UNITED STATES
NUCLEAR REGULATORY COMMISSION
WASHINGTON, D. C. 20555

The Commission has issued the enclosed Amendments Nos. 155, 155 and 152 to Facility Operating Licenses Nos. DPR-38, DPR-47 and DPR-55 for the Oconee Nuclear Station, Units Nos. 1, 2 and 3. These amendments consist of changes to the Station's common Technical Specifications (TSs) in response to your request dated December 12, 1986, as revised on January 29, 1987, and supplemented on February 11, 1987.

ATTACHMENT TO LICENSE AMENDMENTS

SAFETY EVALUATION BY THE OFFICE OF NUCLEAR REACTOR REGULATION
SUPPORTING AMENDMENT NO. 155 TO FACILITY OPERATING LICENSE NO. DPR-38

OPERATIONAL POWER
 IMBALANCE ENVELOPE
 FROM 0 FFPD TO EOC UNIT 1
 OCONEE NUCLEAR STATION

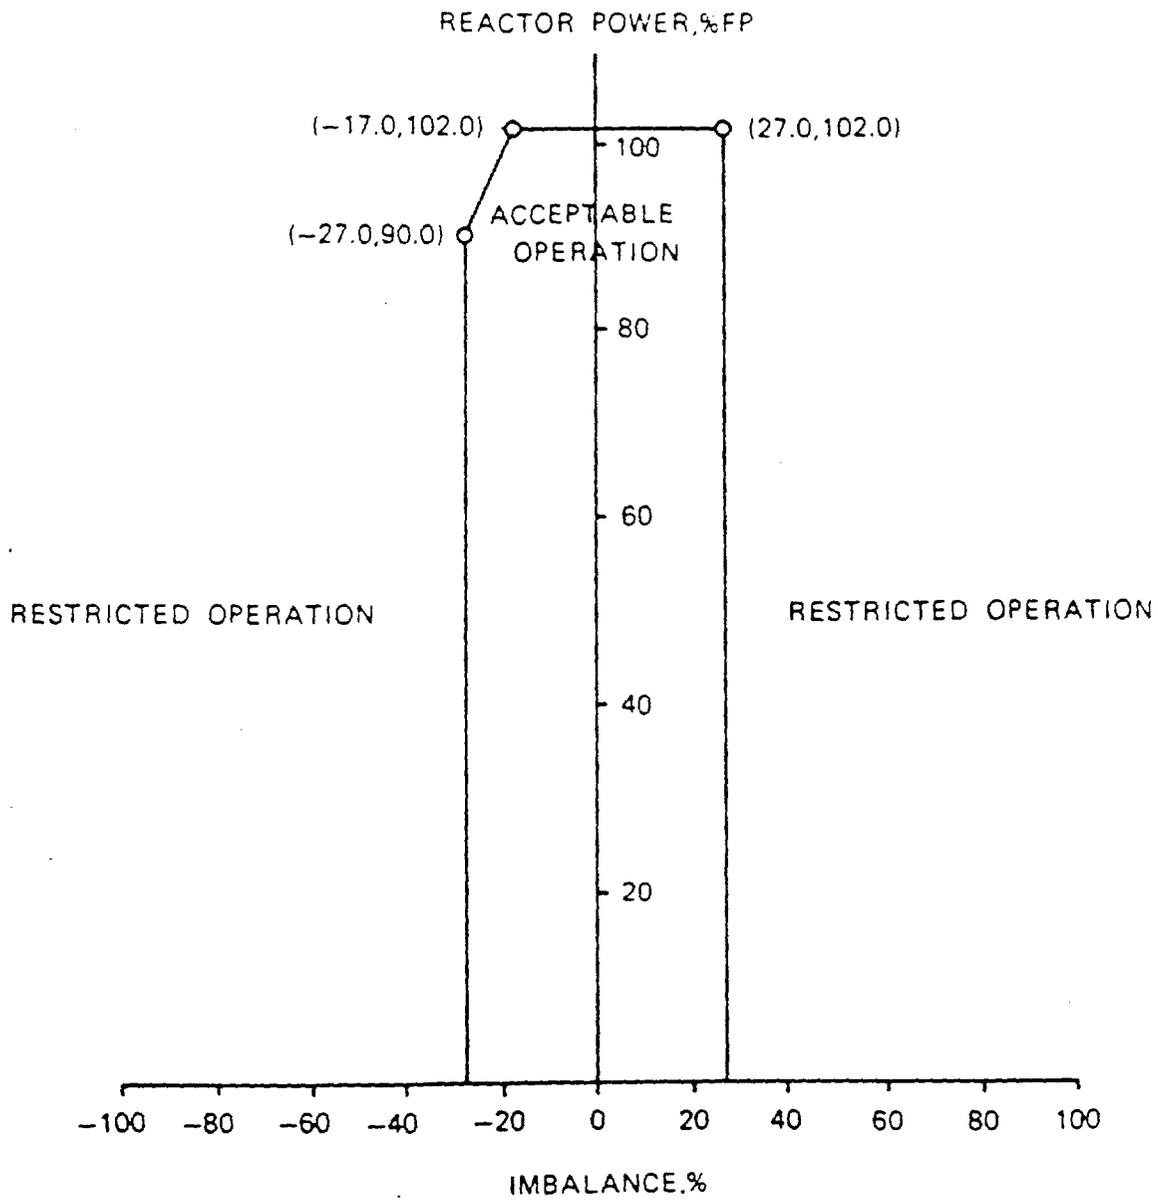
These amendments would also provide a more conservative curve for Oconee Unit 1 Operational Power Imbalance Envelope (Figure 3.5.2-10) to allow 10 CFR Part 50.59 reviews of future core reloads; update TS 3.5.2.4.b.2 (quadrant power tilt) to reflect the fact that power level cutoffs (other than 100%) are no longer applicable to Oconee; delete TS 3.5.2.6 (xenon reactivity) because operating restrictions resulting from transient xenon power peaking are implicitly included in the limits of TS 3.5.2.5 (control rod positions) and proposed TS 3.5.2.6 (reactor power imbalance) and note this in the bases of TS 3.5; and change TSs 3.5.2.7, 3.5.2.8 and 3.5.2.9 to reflect the deletion of TS 3.5.2.6 (xenon reactivity).

OPERATIONAL POWER
 IMBALANCE ENVELOPE
 FROM 0 EFPD TO EOC UNIT 3
 OCONEE NUCLEAR STATION
 Figure 3.5.2-12

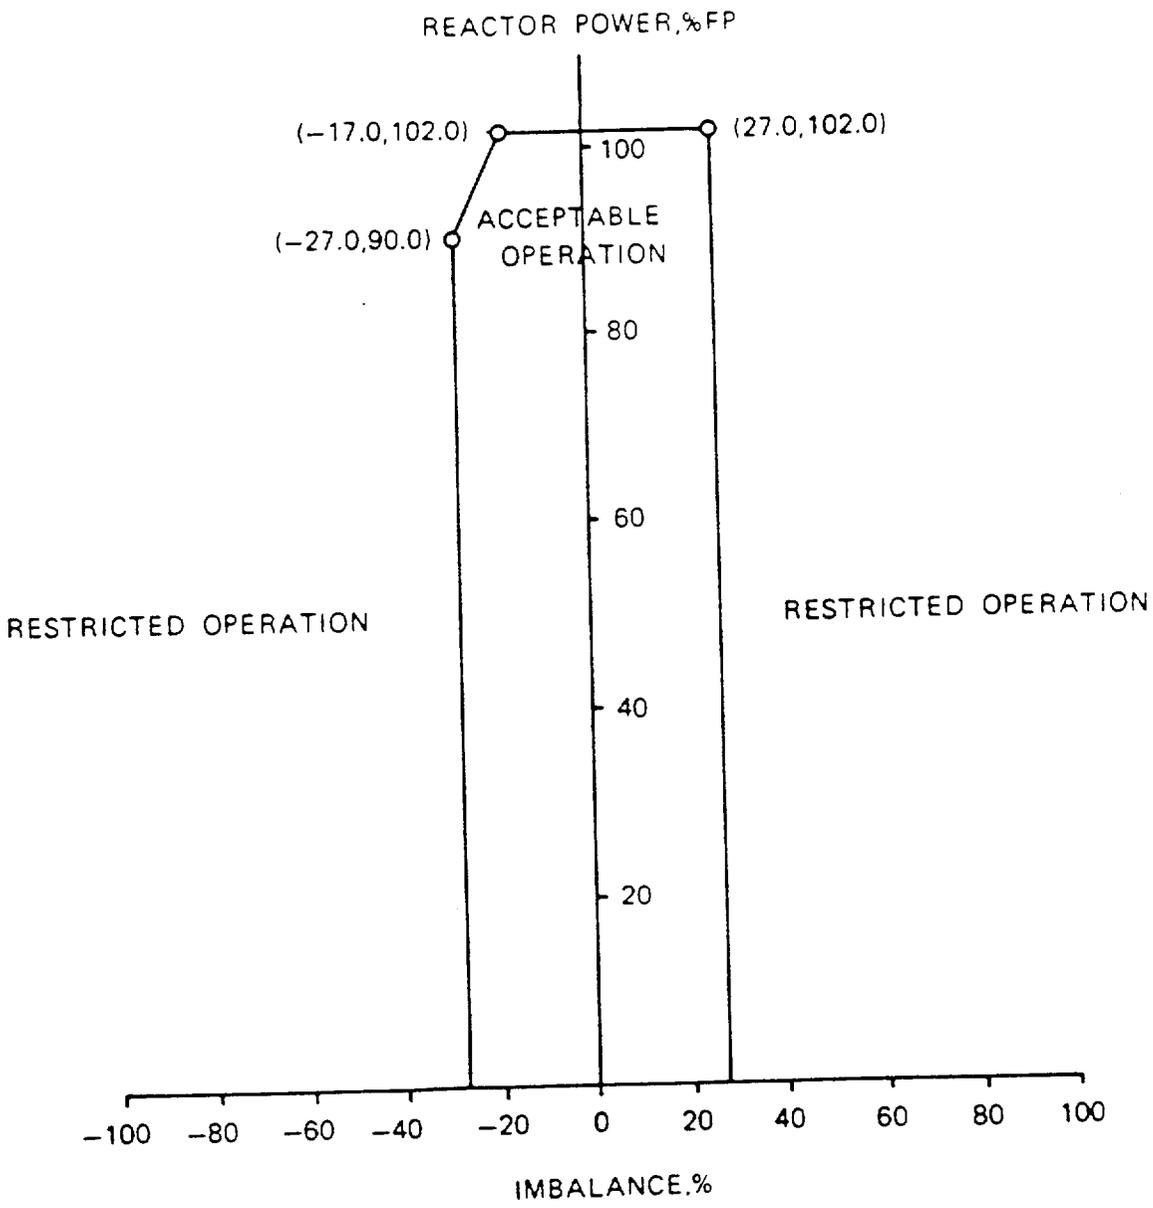
These amendments would authorize changes to the Oconee Nuclear Station TSs which are required to support the operation of Oconee Unit 3 at full rated power during the upcoming Cycle 10. The amendments would change Figure 3.5.2-12, the Unit 3 Operational Power Imbalance Envelope curve. The Figure would be updated to reflect current cycle operating characteristics.

Oconee Unit 3 Cycle 10 TSs have been modified to account for normal cycle-to-cycle fuel changes in power peaking and control rod worths. We have reviewed the proposed specification revisions for Cycle 10. These changes concern the Operational Power Imbalance Envelope (Figure 3.5.2-12). In addition, the licensee has provided a more conservative curve for the Unit 1 Operational Power Imbalance Envelope (Figure 3.5.2-10) in order to reduce future TS changes and to allow more of their future reload cores to be reviewed under 10 CFR 50.59. On the basis that approved methodology was used to obtain these limits which assure that general design criteria 10 and 12 are satisfied, we find these TS modifications acceptable.
